**HPBC DEVELOPMENT CONTROL COMMITTEE**

**UPDATE SHEET**

**HPK/2021/0145 – Foxlow Farm Local Centre, Ashbourne Road, Buxton**

*Nursery Garden Area (demarcated)*

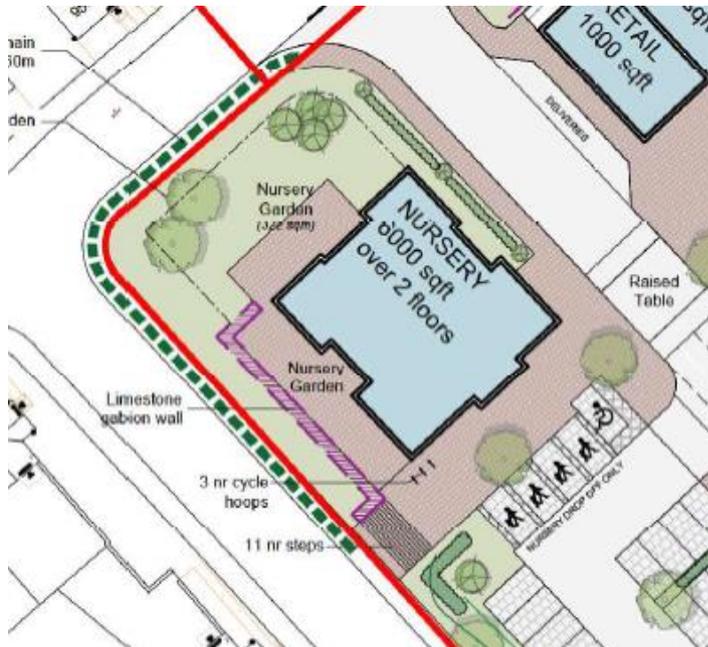
Further clarification has been requested on the amount of outdoor space to be delivered for the proposed nursery. Whilst the final area / amount of outdoor space to be delivered will depend and respond to the end occupiers requirement, the outdoor space will extend beyond the hardstanding areas illustrated on the proposed site plan and include some of the grassed / landscape areas adjacent to the internal access road.

To provide further information on this, enclosed with this letter is an illustrative plan which shows how the nursery garden could be provided. This would provide an outdoor space of 322m<sup>2</sup> across a mix of hardstanding and landscaped / grassed area. The level of outdoor space that can be provided for children is undoubtedly a consideration in parents / guardians choosing which nursery their child attends and as such it is important that an appropriate level of provision is delivered to ensure a successful business. As such it is in the commercial interests of the operator to deliver a sufficient amount of outdoor space to ensure a high quality of childcare and attract custom.

It is considered that the proposed outdoor areas will deliver a sufficient amount of outdoor space to serve the needs of any potential end operator for the nursery. The applicants; HDD, have delivered in excess of 20 children's day nurseries and as such have significant experience in delivering suitable buildings and sites that meet operator's needs".

Similarly, a further planning condition to agree the approval of a scheme including area, landscaping and boundary treatment through an appropriately worded condition is also recommended.
